HANNAH RIDGE AT FEATHERGRASS FILING NO. 5

CONSTRUCTION PLANS

HANNAH RIDGE AT FEATHERGRASS FILING NO. 5, 6 & 7 OVERLOT GRADING AND EROSION CONTROL PLAN			
DESIGNED BY	KRC	SCALE	DATE 10/12/18
DRAWN BY	KC	(H) 1" = 50'	SHEET 3 OF 11
CHECKED BY		(V) 1" = NA	JOB NO. 1116.05

HANNAH RIDGE AT FEATHERGRASS
FILING NO. 5
STREET IMPROVEMENT PLANS
ELECTRONIC DRIVE/DAPPLES COURT

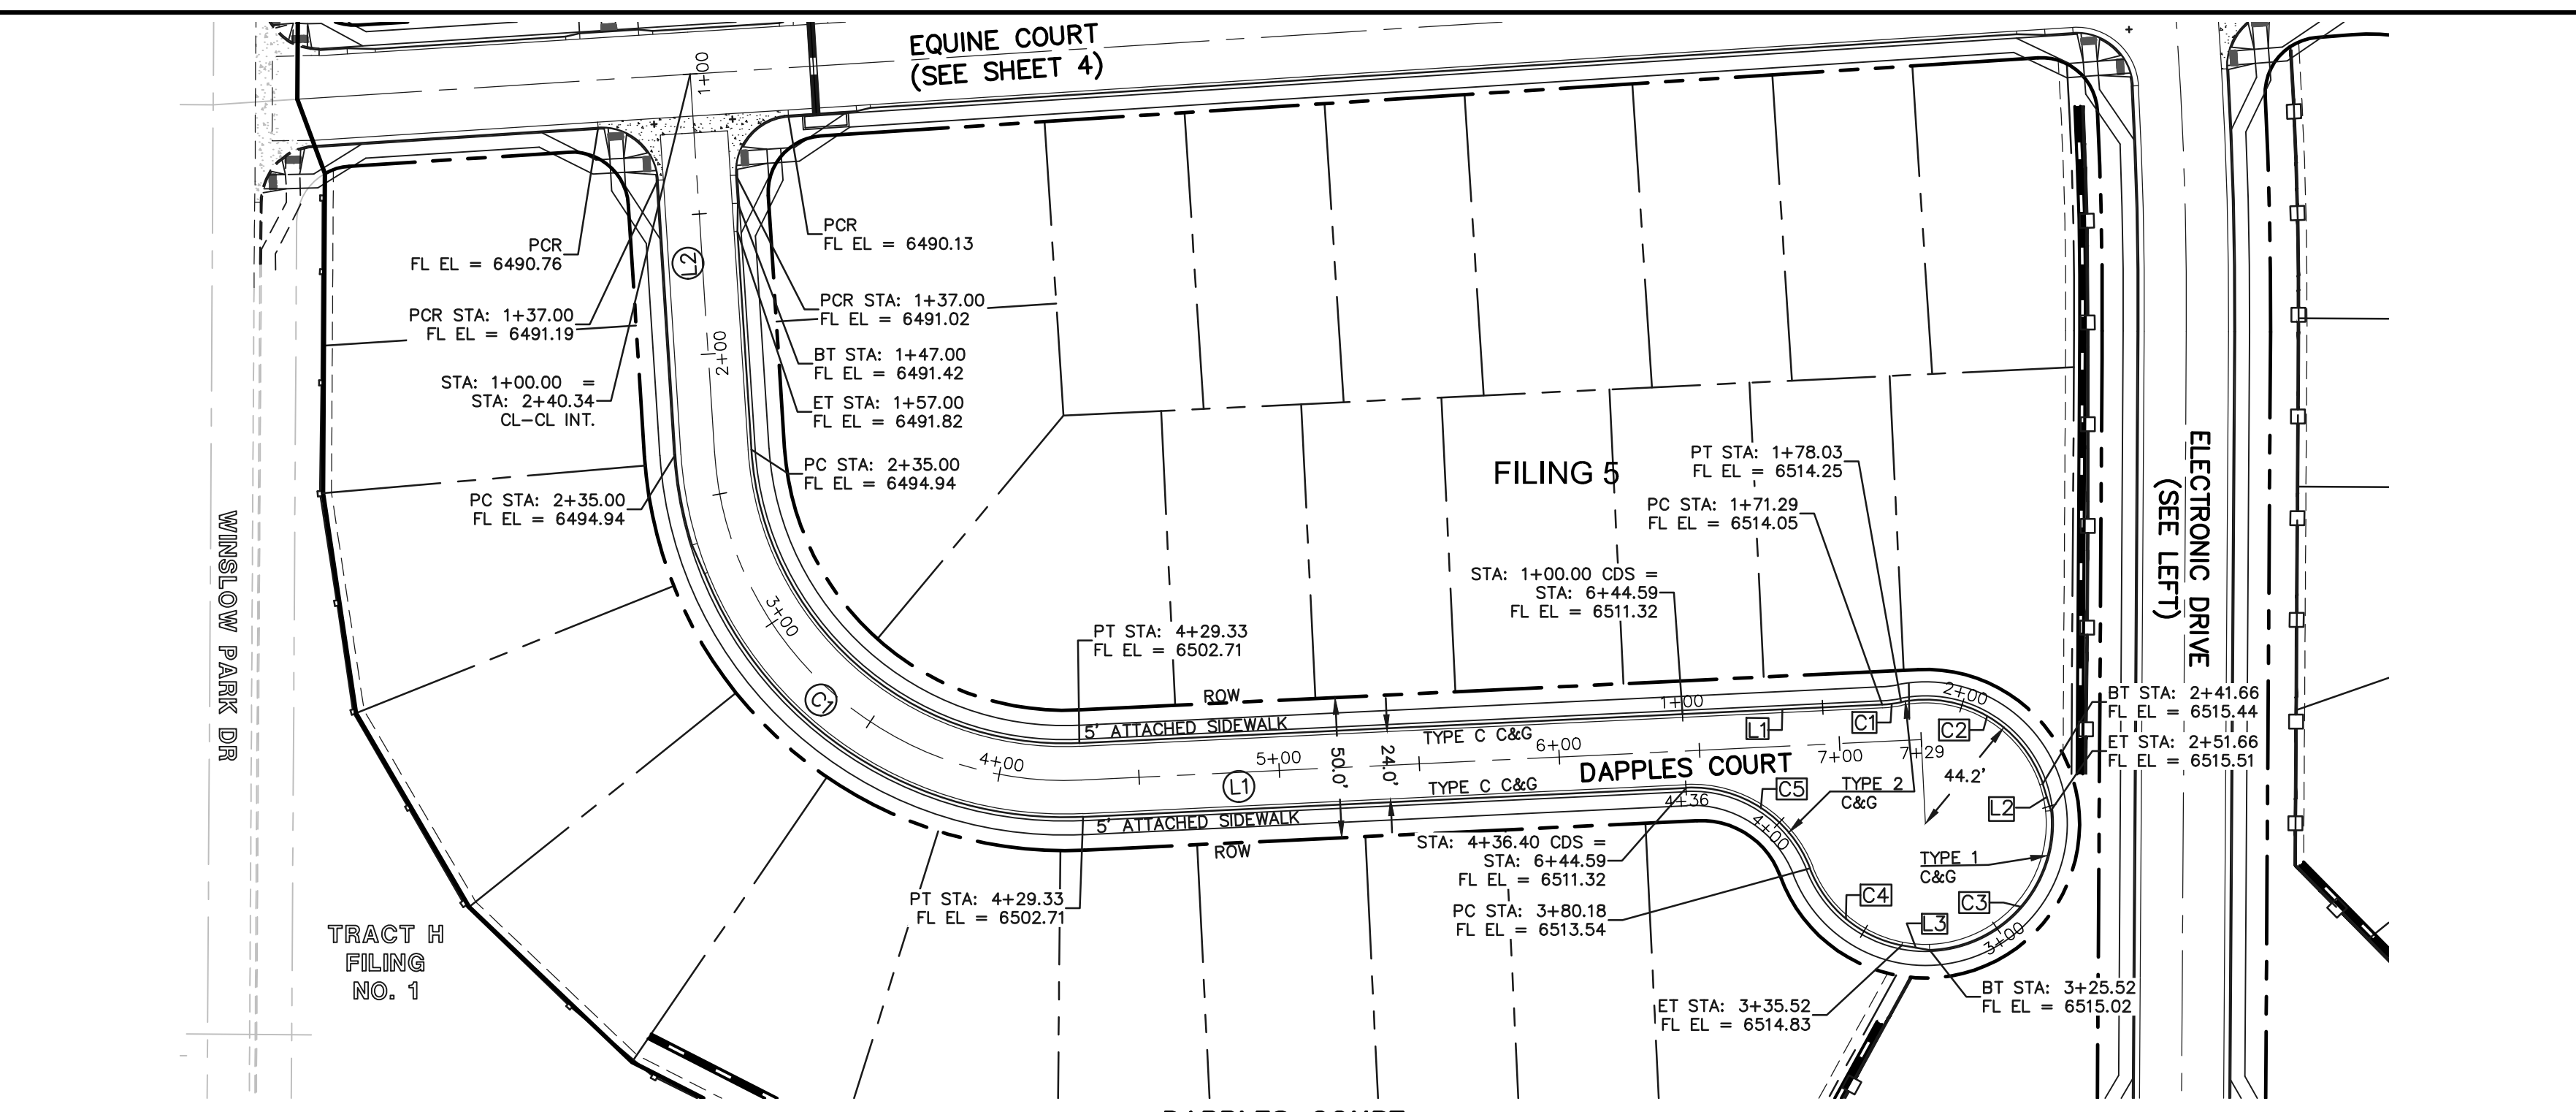
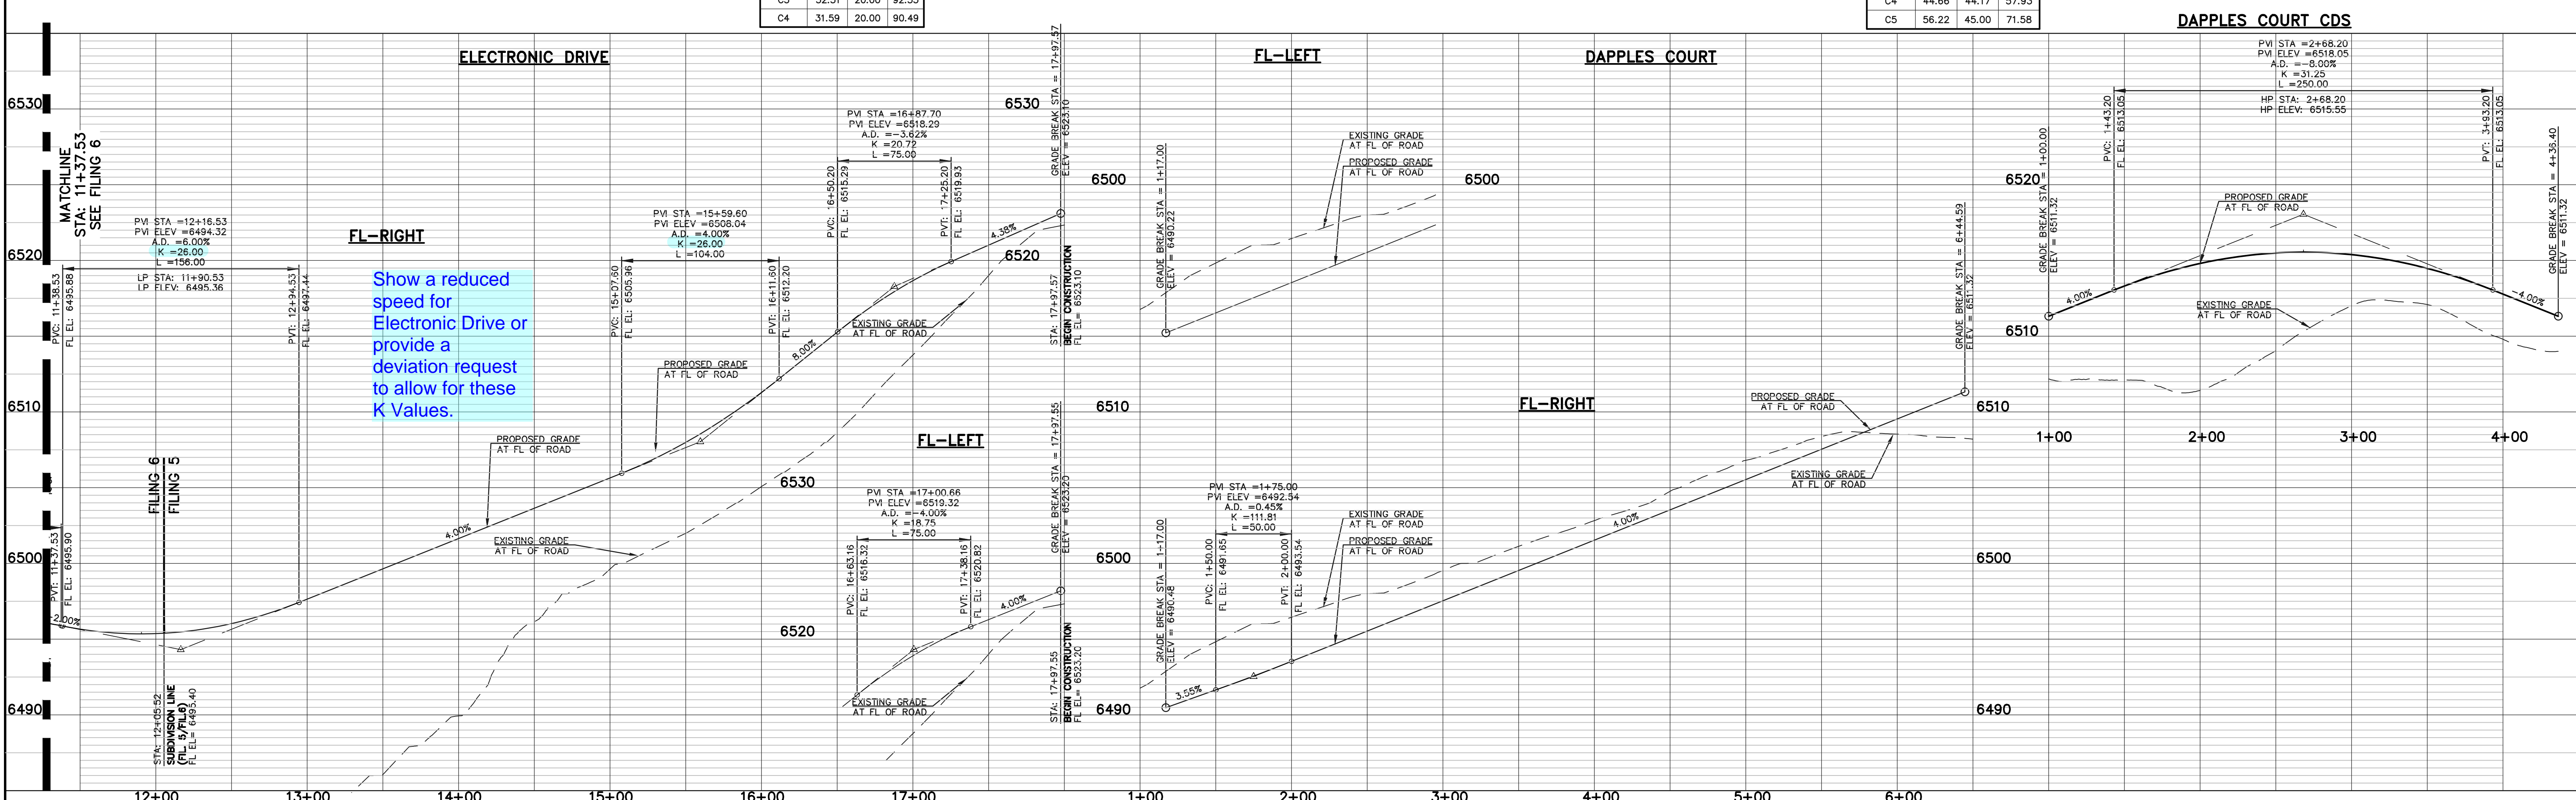
Show a reduced speed for Electronic Drive or provide a deviation request to allow for these K Values.
